MARICOPA COUNTY
Department of Transportation

MEMORANDUM

Subject: Revision to Section 405 MONUMENTS and Detail 120

Case 14-02

TYPE 'B'
(WITHOUT FRAME)

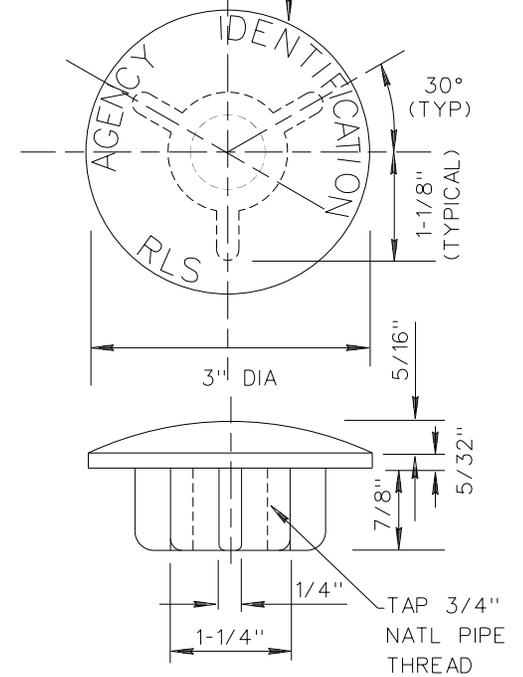
PURPOSE: Updated specification to match current details and requirements.
Deleted the usage note for Type C Monument (prior note #3).
Modified Type B Monument to have the depth recessed six inches below finished grade when located in an unpaved roadway or alley.

3. FOR UNPAVED STREETS AND ALLEYS SET TOP OF MARKER SIX INCHES BELOW FINISHED GRADE.
4. CAP TO BE CONSTRUCTED OF RED BRASS OR BRONZE.
5. LETTERS TO BE APPROX. 1/32" WIDE & 1/32" DEEP.
